## HISTORIC AND DESIGN REVIEW COMMISSION

**HDRC CASE NO:** 2015-386  
**COMMON NAME:** 2231 SE Military Dr  
**LEGAL DESCRIPTION:** NCB 10930 BLK LOT 20 (MNFA DEVELOPMENT SUBD) 2013-NEW ACCT PER SPLIT PER PLAT 9642/4-6 FILED 6/8/2012  
**ZONING:** C2 S RIO-6  
**CITY COUNCIL DIST.:** 3  
**APPLICANT:** Mark Nbuille/Villa Park Architecture  
**OWNER:** Money Cay, LLC  
**TYPE OF WORK:** Final approval of new construction  
**REQUEST:**

Applicant is requesting a Certificate of Appropriateness for approval to construct a new retail shell building at 2231 SE Military Drive. Signage is not a part of this request.

PROPOSED SITE DEVELOPMENT PLAN

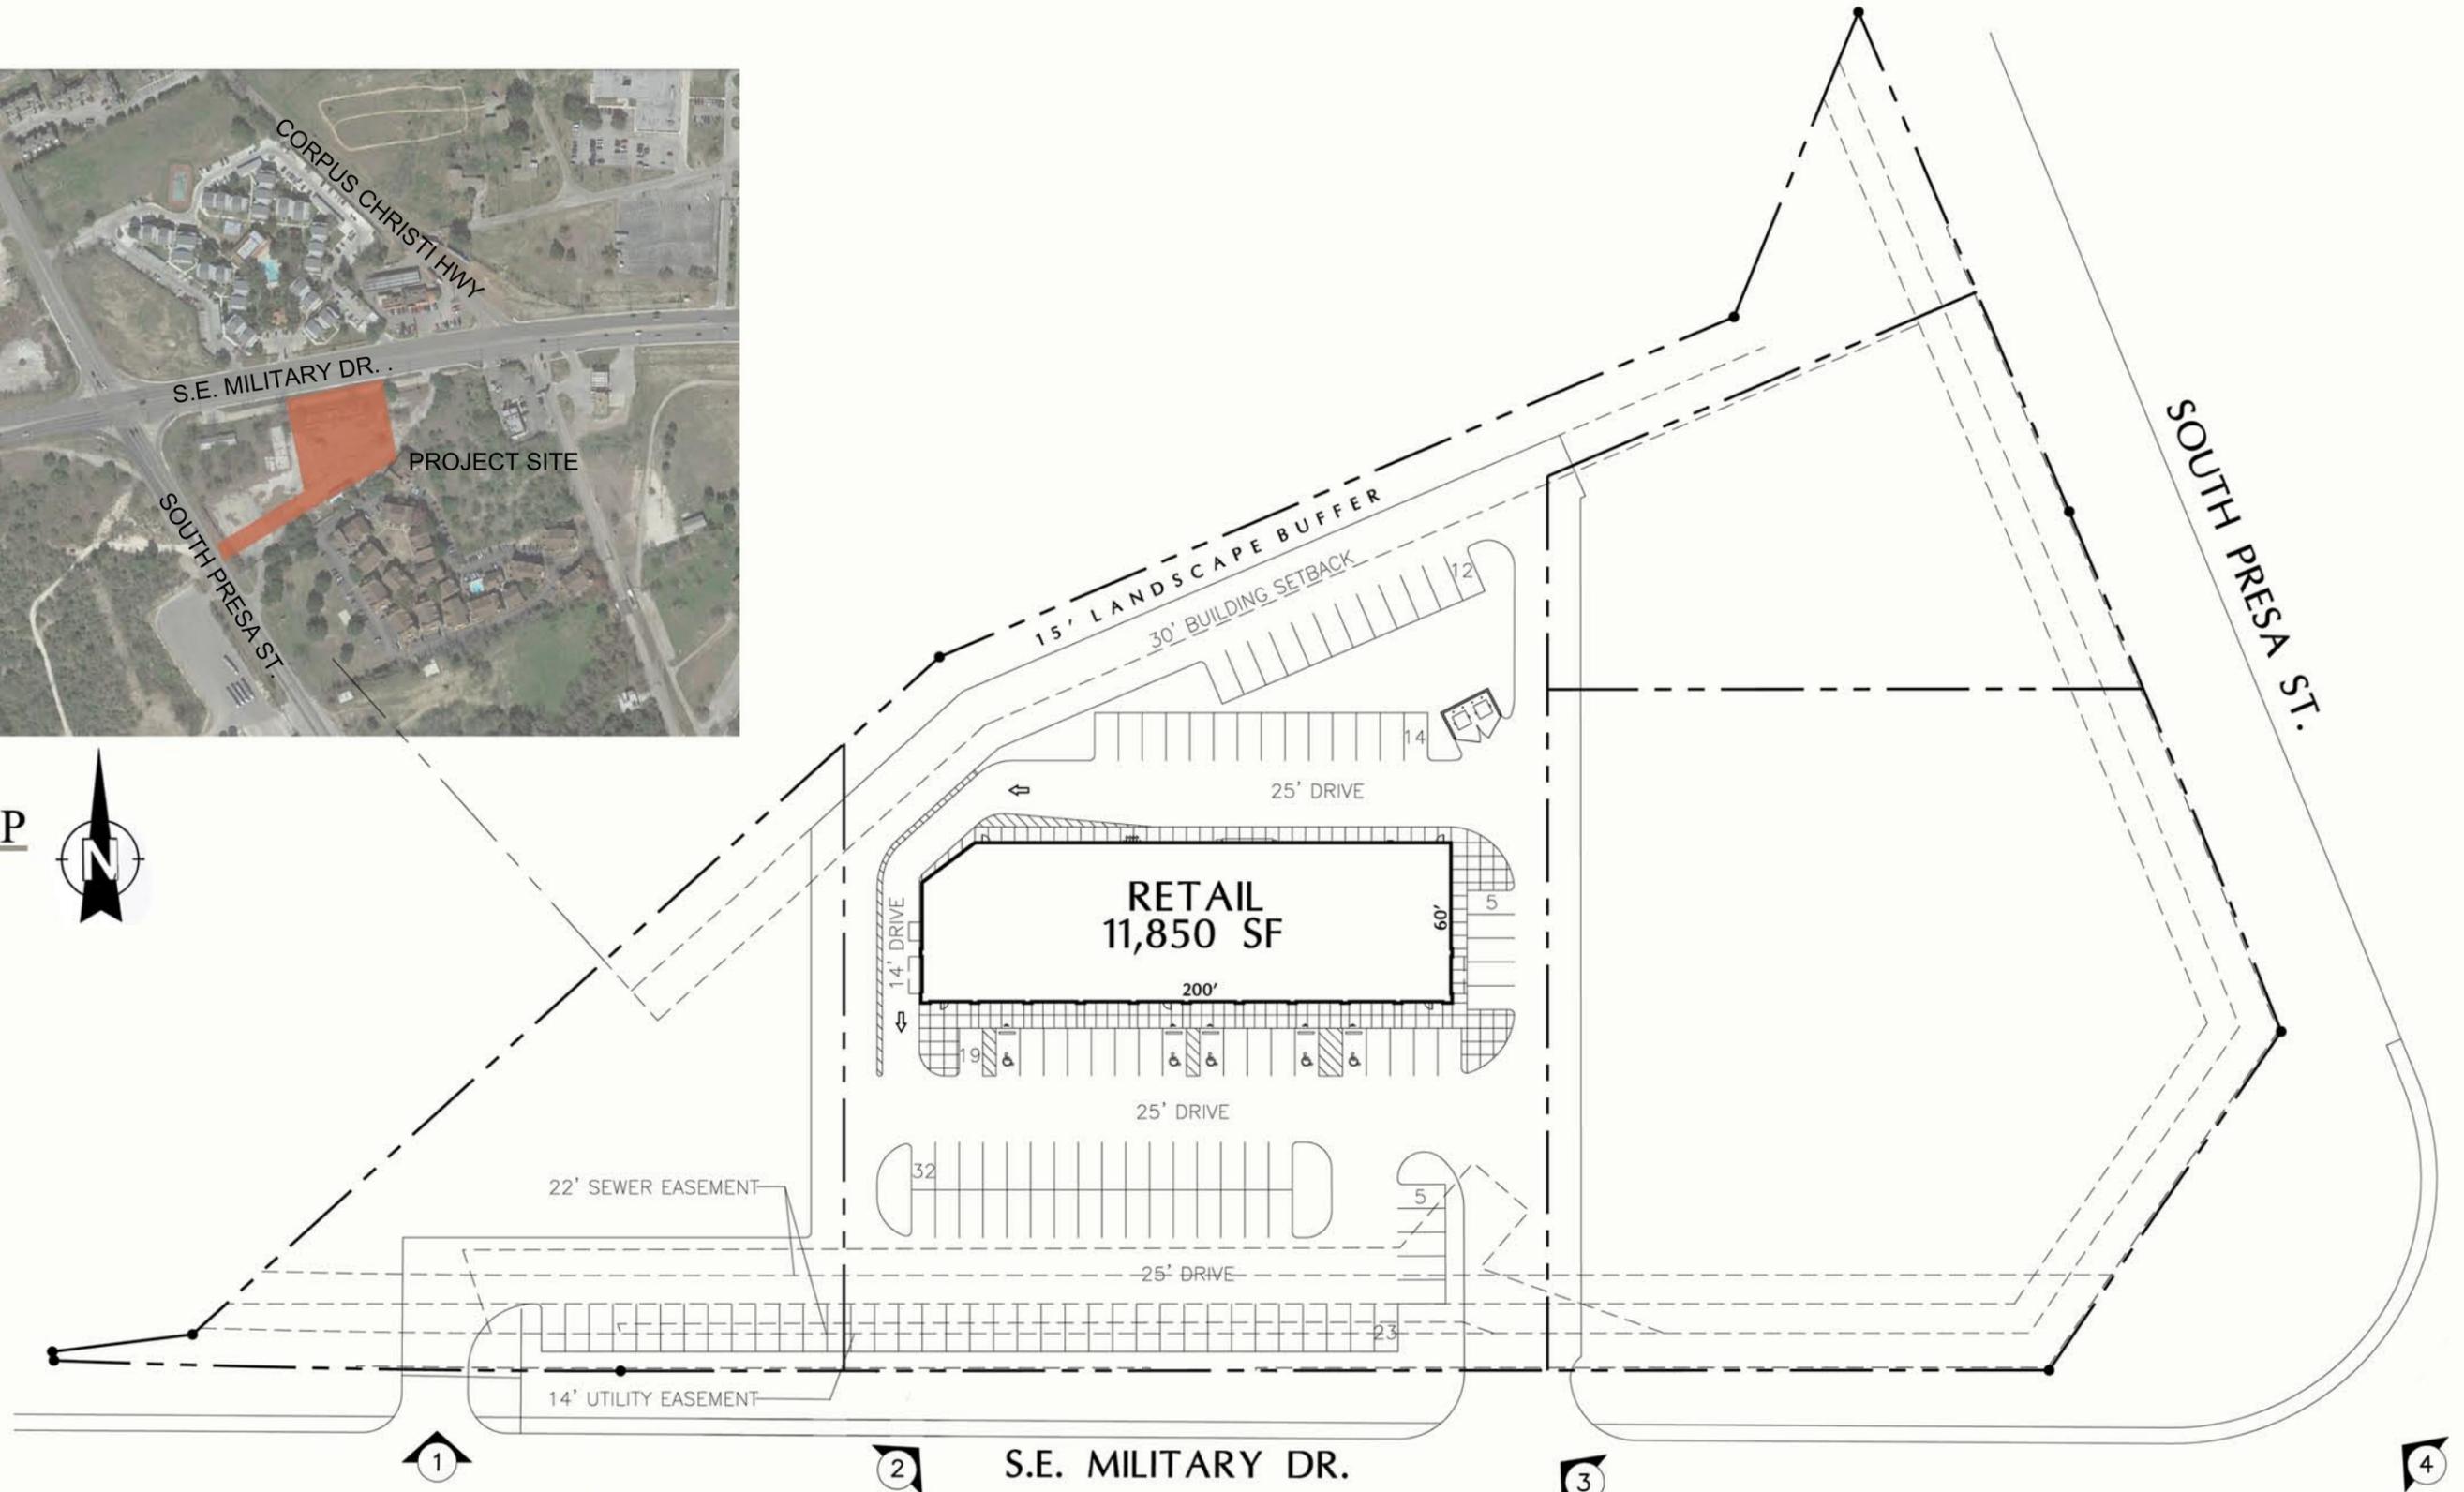
- d. The applicant has noted two curb cuts in the provided site plan; both for automobile traffic to access surface parking lots. Per the UDC Section 35-672(b)(1)(B), curb cuts may be no larger than twenty-five (25) feet. The applicant is responsible for complying with this section of the UDC.

Staff recommends approval based on findings a through l with the stipulation that the applicant provide information regarding the screening or mechanical equipment and that the applicant provide space for bicycle parking on the site.

PROPOSED DESIGN

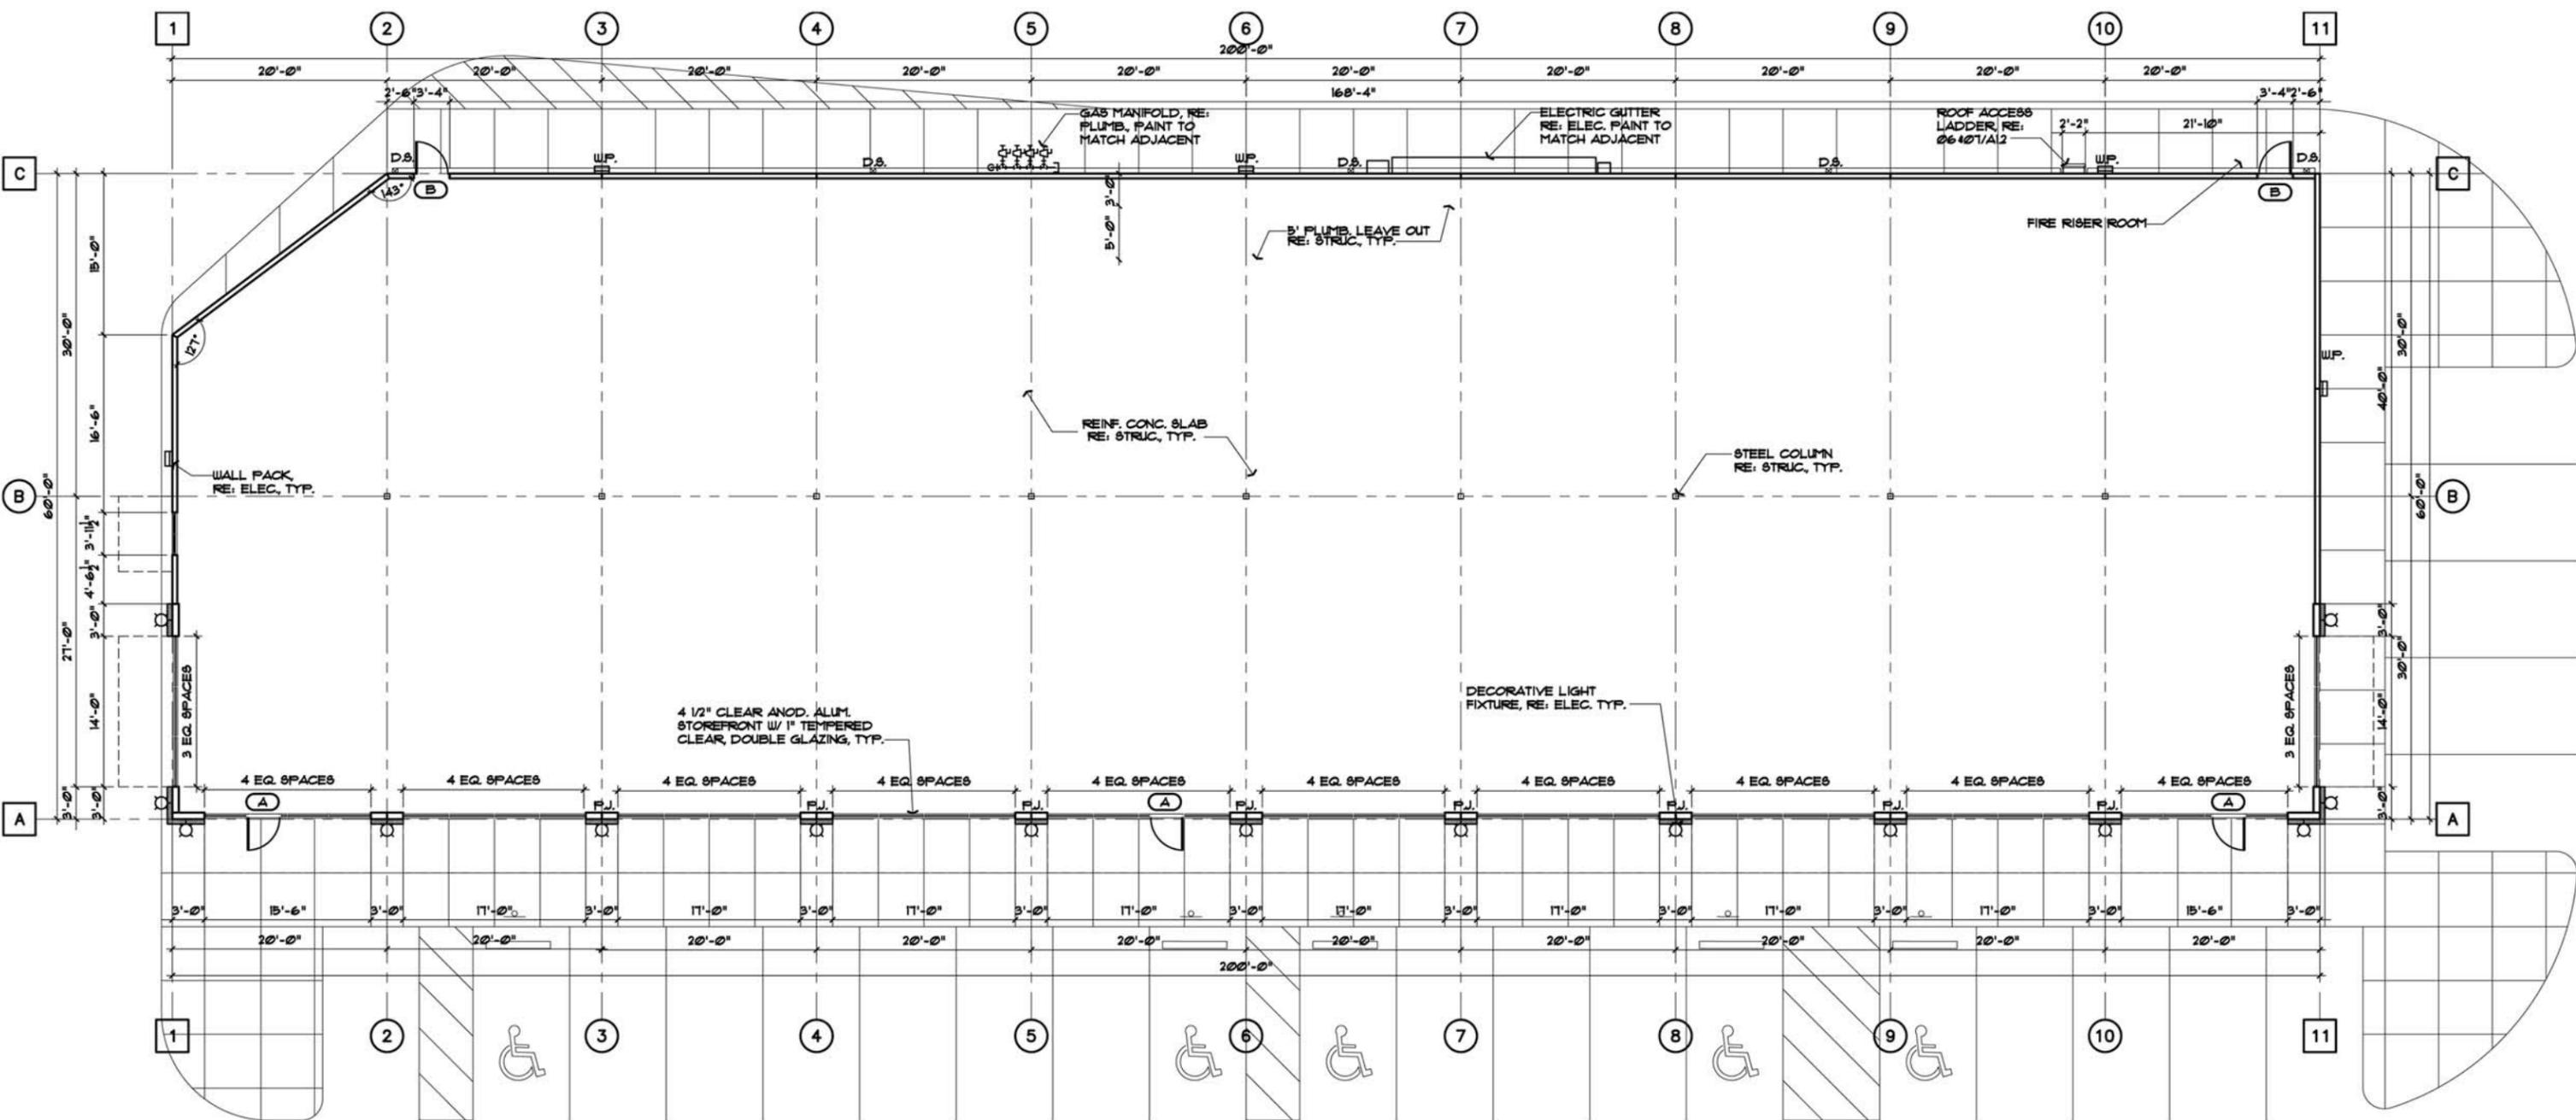
- l. According to the UDC Section 35-674(g), awnings and canopies are to be used to accentuate the character defining features of the building. The applicant has applied the proposed awnings to separate the façade as well as provide a reference to the building's entrances. This is consistent with the UDC.
